# Work Order ID 96852

Item Name: Crosstube Turning Detail

<b>DART AEROSPACE LTD</b>	<b>Work Order:</b>	96852
<b>Description:</b> Crosstube Assembly (412 High Aft)	<b>Part Number:</b>	D412-664-243
<b>Inspection Dwg:</b> D412-664-243 <b>Rev:</b> E		<b>Page 1 of 2</b>

DRAWING NO. D412-664-243	TITLE CROSSTUBE ASSEMBLY (412 HI AFT)	REV. E	DART AEROSPACE LTD ENGINEERING ORDER		D.E.O. NO. D412-664-243-E-1	SHEET NO. SHEET 1 OF 2	SCALE NTS
DRAWN	CHECKED	MFG. APPR.	APPROVED	DE APPR.			
DATE 11.03.31	DATE 11/03/31	DATE 11.03.31	DATE 11/03/31	DATE 11.03.31

**D412-664-243  
ASSEMBLY DETAIL**

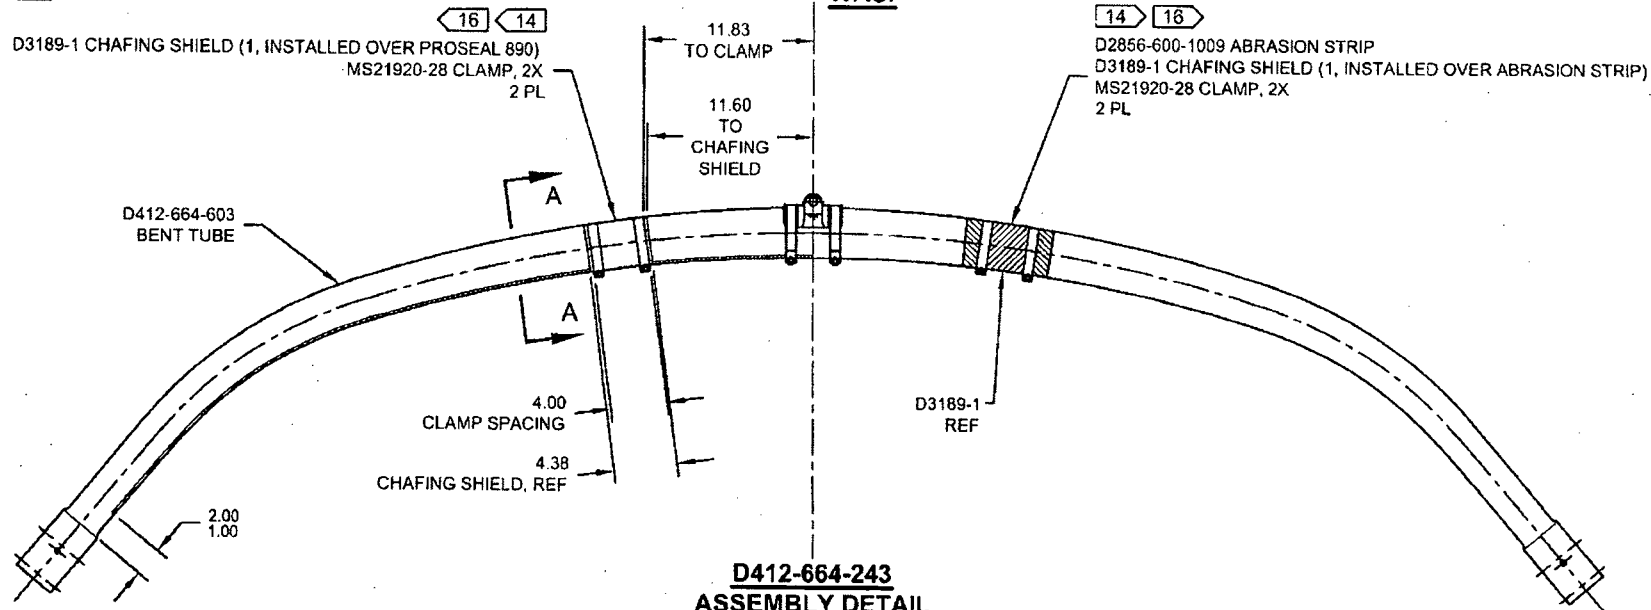
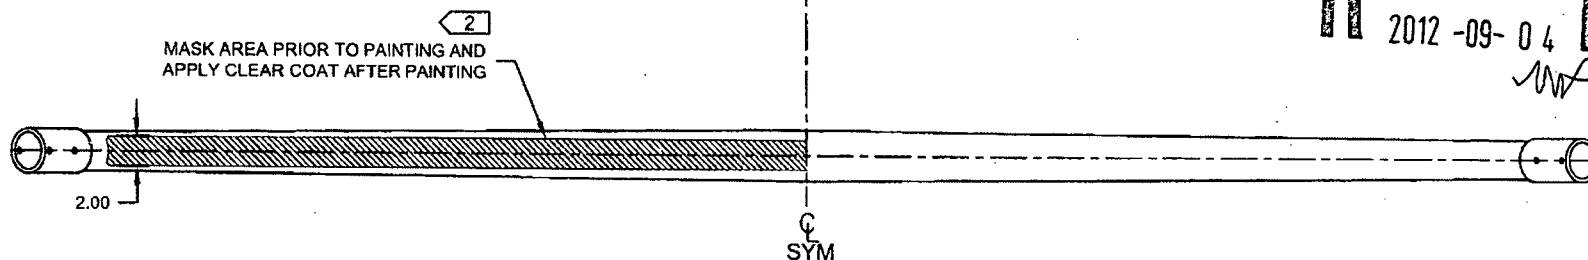
**PURPOSE:**

REMOVED ABRASION STRIP IN FAVOR OF A THIN LAYER OF PROSEAL 890. UPDATE INSTALLATION OF CHAFING SHIELDS AND REDUCE TORQUE TO 40-50 IN-LBS. THIS ENGINEERING ORDER SUPERCEDES DEO D412-664-243-E-1.

**IS:**

D2856-600-1009 ABRASION STRIP  
D3189-1 CHAFING SHIELD (1, INSTALLED OVER ABRASION STRIP)  
MS21920-28 CLAMP, 2X  
2 PL
